ADDENDUM NO. 2 – BID PACKAGE NO. 1

PROJECT NAME: UNL – Animal Science Reroof – Bid Package I – Standing Seam Metal Roof
UNL PROJECT NUMBER: A102P024

DATE OF ISSUANCE: April 25, 2012
DATE OF BID OPENING: May 2, 2012

1 ROOF FALL PROTECTION TIE-OFF SECTION DETAIL

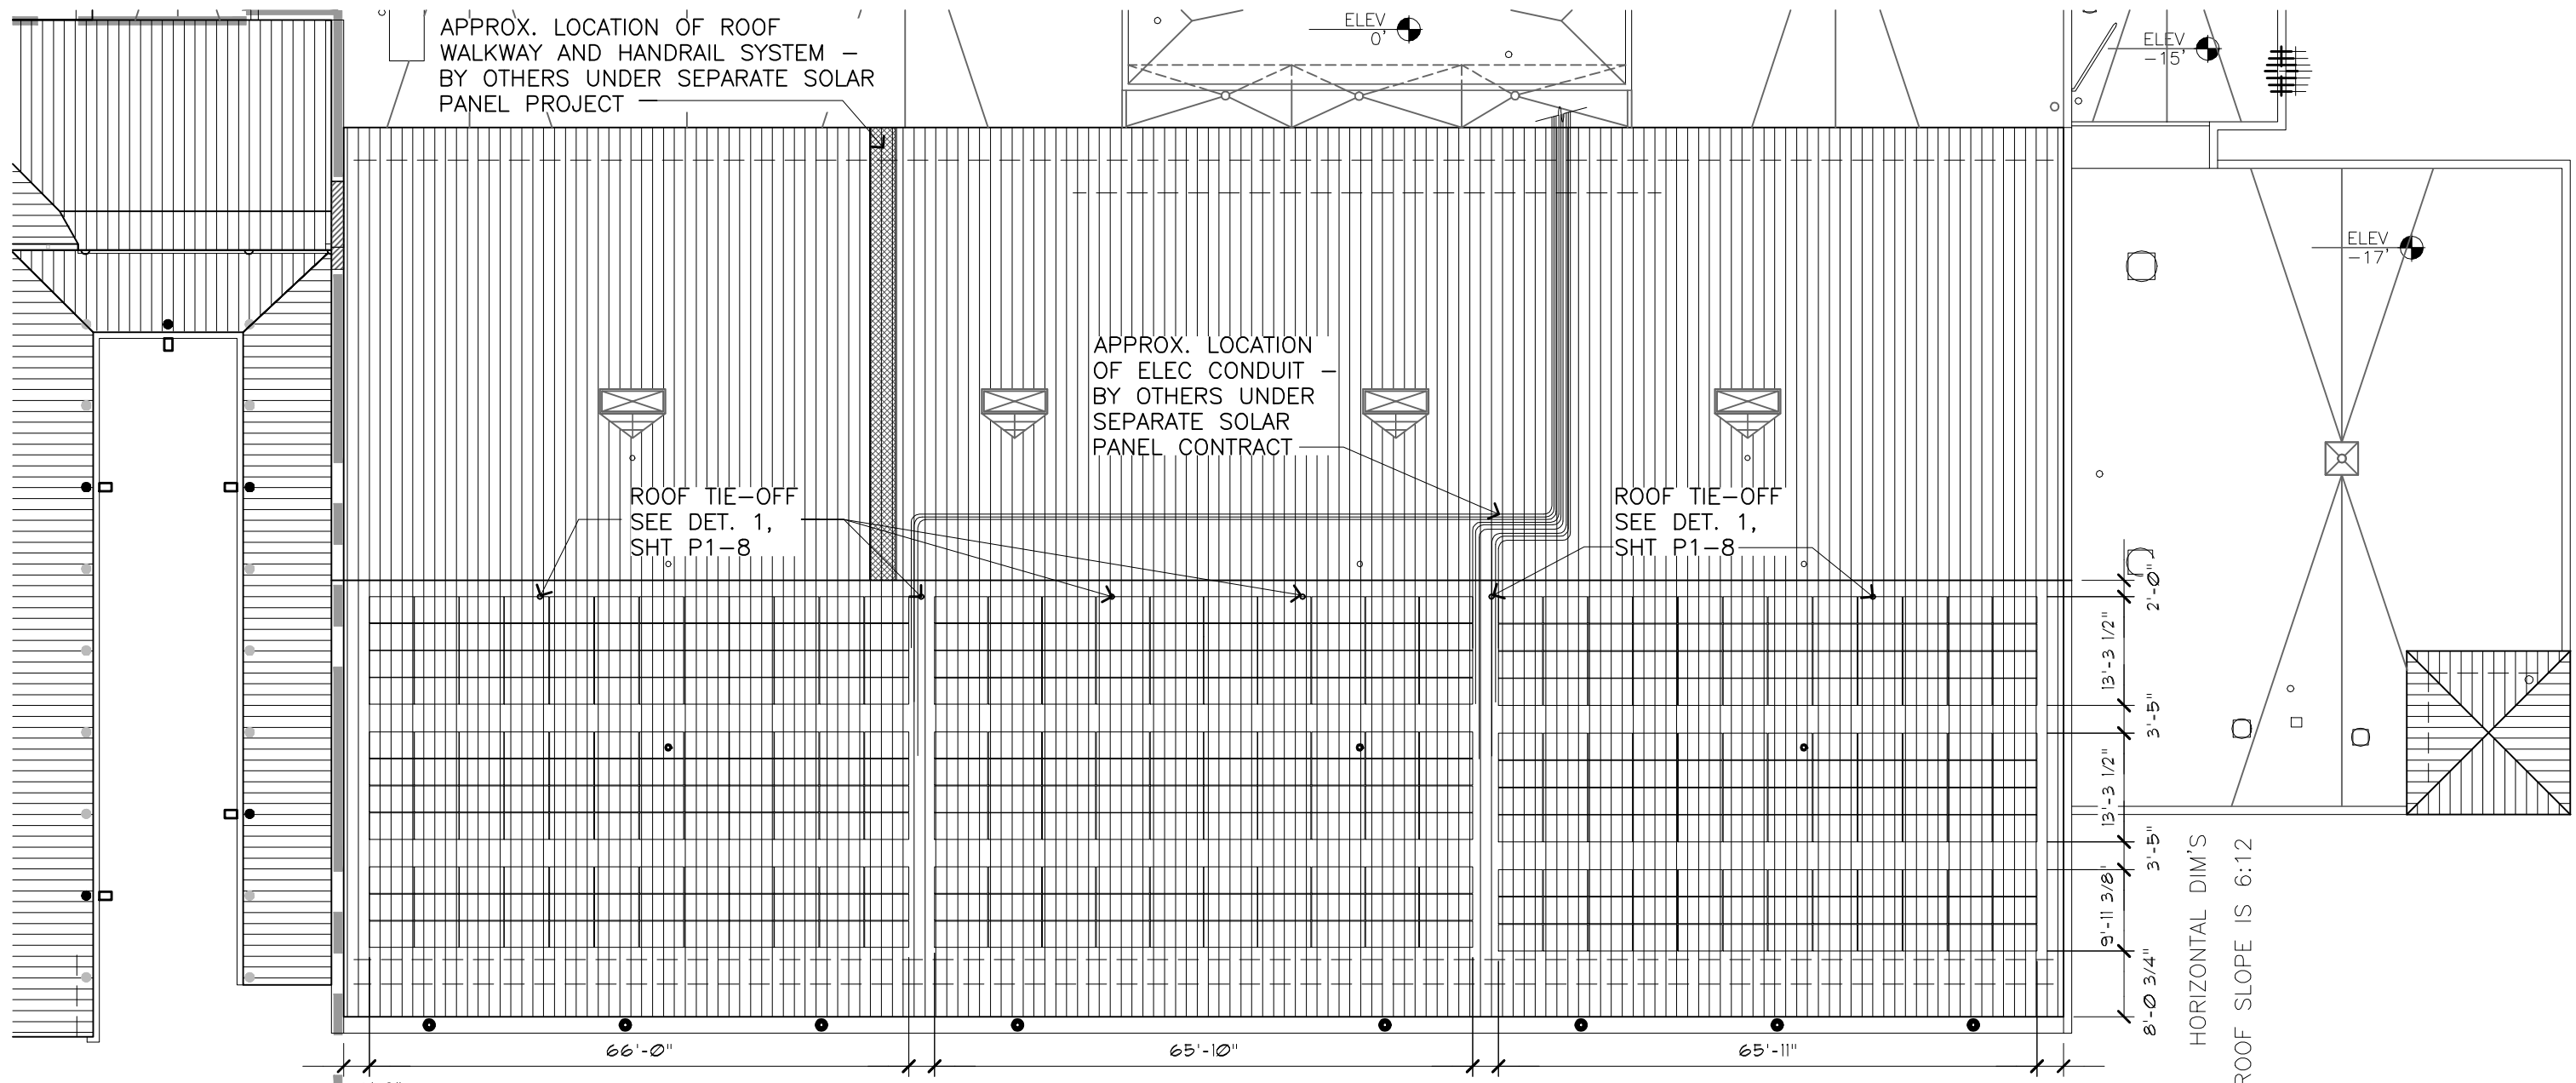
At page 3, add section 2.06 and 3.02 to provide and install 6 stainless steel roof fall protection tie-off supports as shown on the attached detail 1, sheet P1-8.

8. Add Sheet Note No. 33 as follows: "33. Include 6 stainless steel roof fall-protection tie-off supports to be attached to the existing steel roof beams above the Arena D103, at the locations shown on the attached partial Roof Plan - detail 3, sheet P1-7 and installed per the attached detail 1, sheet P1-8. The exact tie-off locations will be determined by the Architect. Include roof manufacturer's current standard roof penetration flashing system at tie-off penetration.

1. Add attached detail 1, sheet P1-8, 'Roof Fall-Protection Tie-Off Section Detail'.

ARENA D103 ROOF PLAN
APPROX. SOLAR PANEL LOCATIONS AT SOUTH ROOF AREA

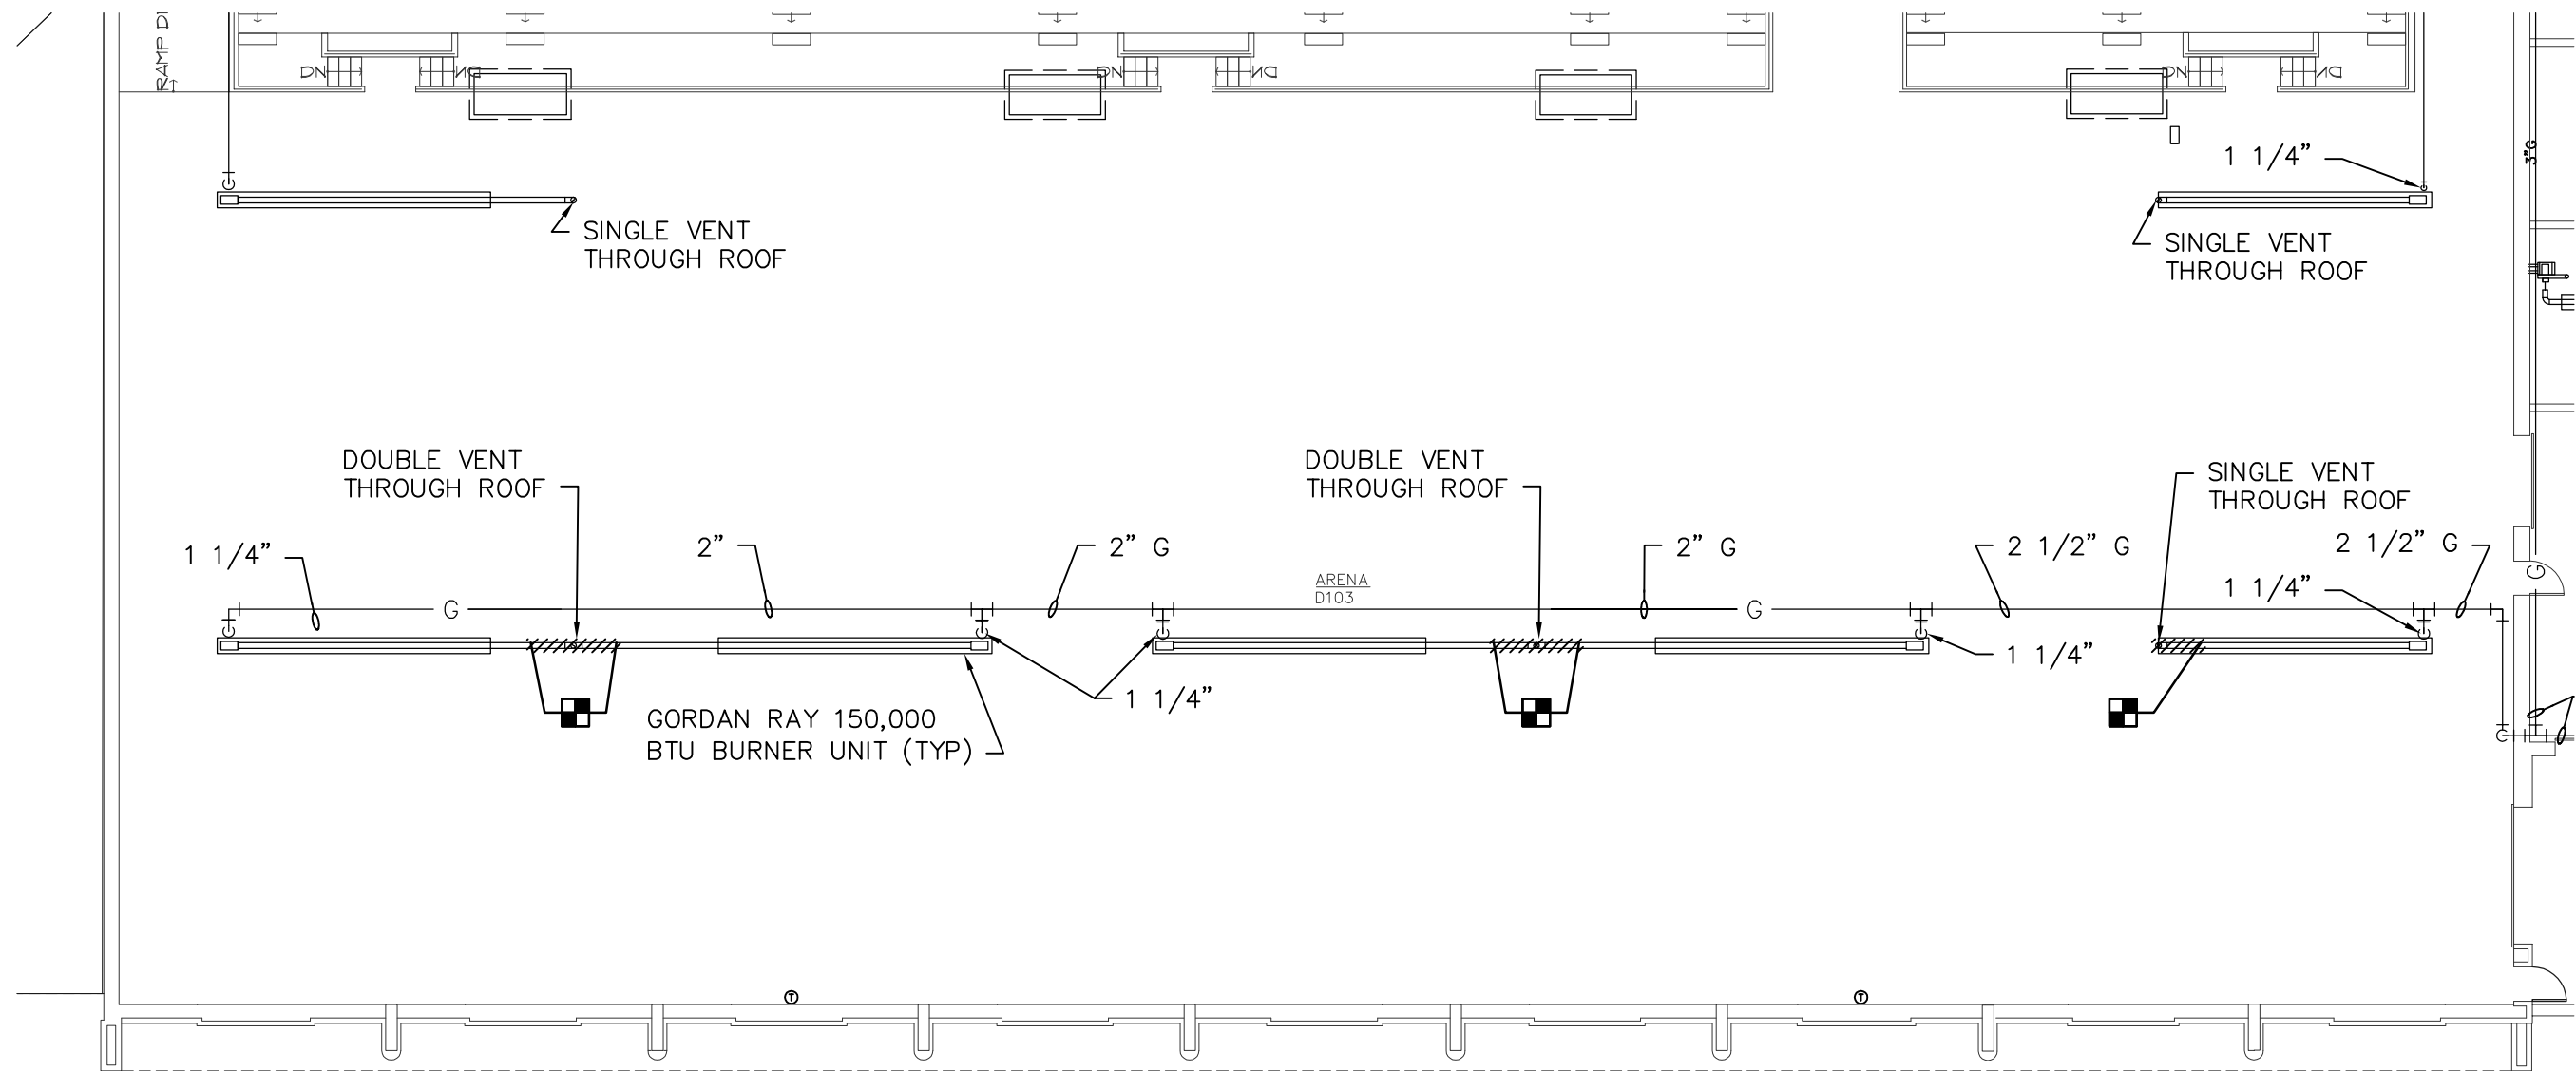
5. At 'General Roof Notes', add the following Note K:
"K. The separate Solar Panel Project will include electrical conduit runs. The conduit runs will mount to the standing seam metal roof with a mounting system similar to the UniRac Aceclamp Jr (or Dynamic Fastener S-5) with the UniRac SolarMount Standard Rail and associated accessories. The mounting system and final conduit locations will be determined by the Owner. See attached partial Roof Plan - detail 3 sheet P1-7 for approximate conduit run locations.

6. At 'General Roof Notes', add the following Note L:
"L. The separate Solar Panel Project will include a rooftop walkway system similar to 'Uni-Strut Rooftop Walkway System'. The walkway system will mount to the standing seam metal roof with a mounting system similar to the UniRac Aceclamp Jr (or Dynamic Fastener S-5) The mounting system and final location will be determined by the Owner. See attached partial Roof Plan - detail 3 sheet P1-7 for approximate walkway system location.

1. Add attached partial roof plan detail 3, sheet P1-7.

PARTIAL FIRST FLOOR MECHANICAL RENOVATION PLAN - AREA D

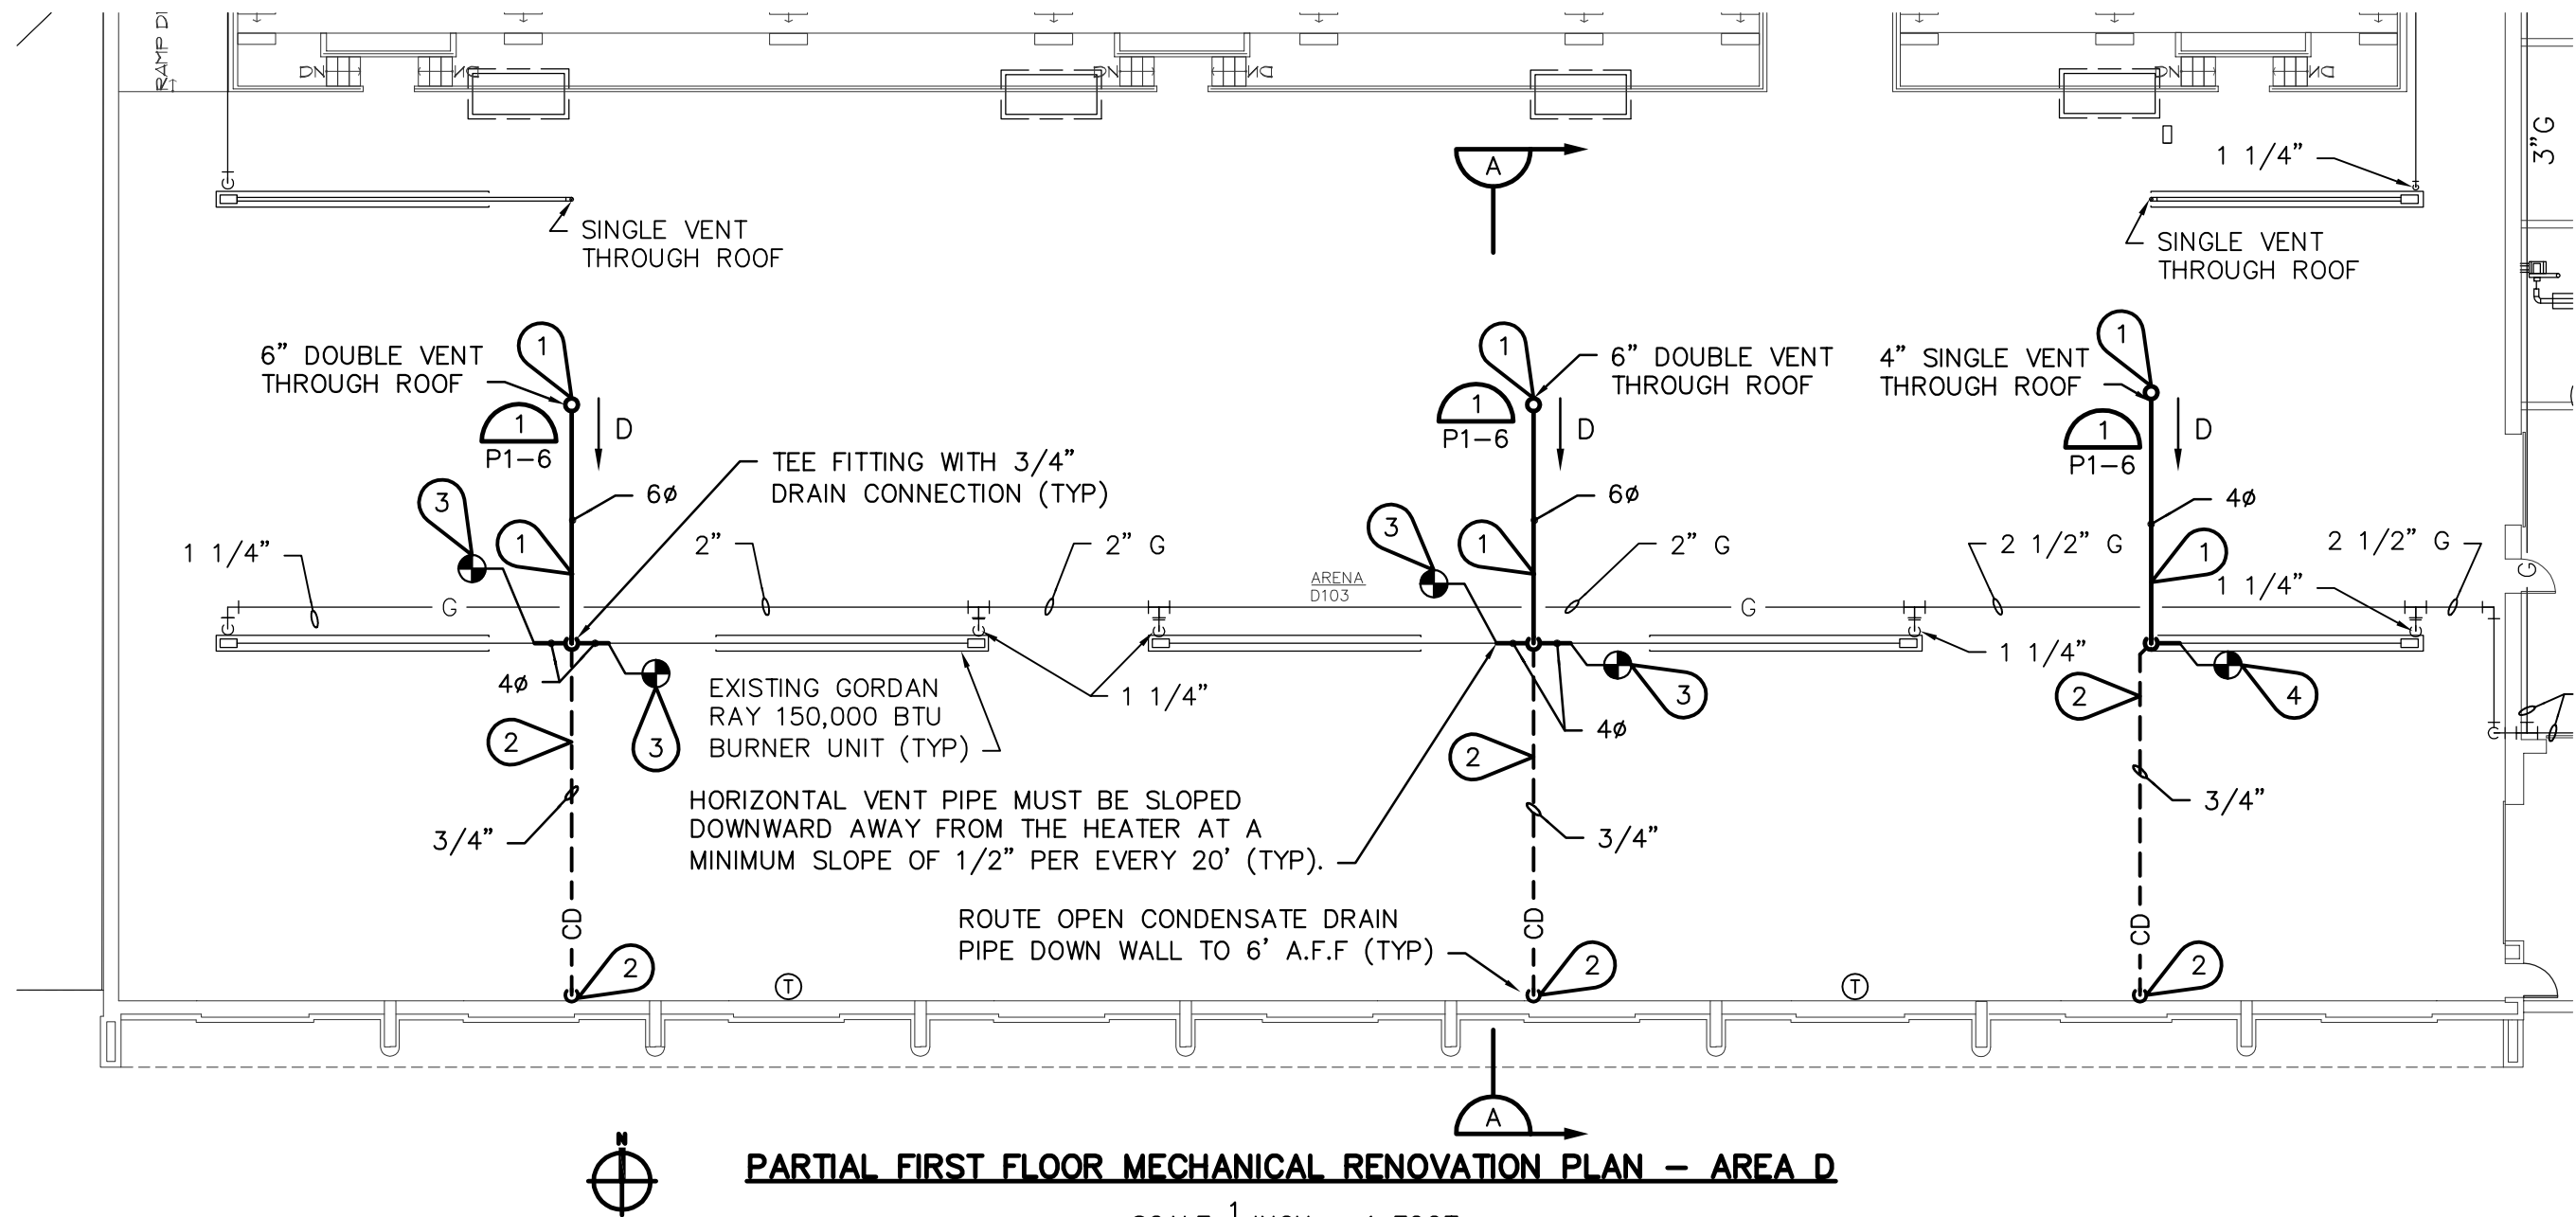
7. At Sheet Note No. 28, add the following: "See attached sheets 1 of 3, 2 of 3 and 3 of 3 from Farris Engineering for mechanical vent requirements. At the roof penetrations, each relocated vent is to have a box base sized to match the existing vent base boxes. Each box is to be pre-finished sheet metal cladding on 5/8" FRT OSB on 2x6 wood blocking with a prefinished sheet metal cricket on the high side. Provide adequate clearance between wood blocking and vent. Flash the box into the standing seam roof per roof manufacturer's current written instructions and details."

3 CONNECT NEW 4" VENT FROM EACH OF THE TWO EXISTING BURNERS INTO ONE 6" VENT STACK THROUGH THE ROOF.

4 CONNECT NEW 4" VENT FROM THE EXISTING BURNER TO A 4" VENT STACK THROUGH THE ROOF.
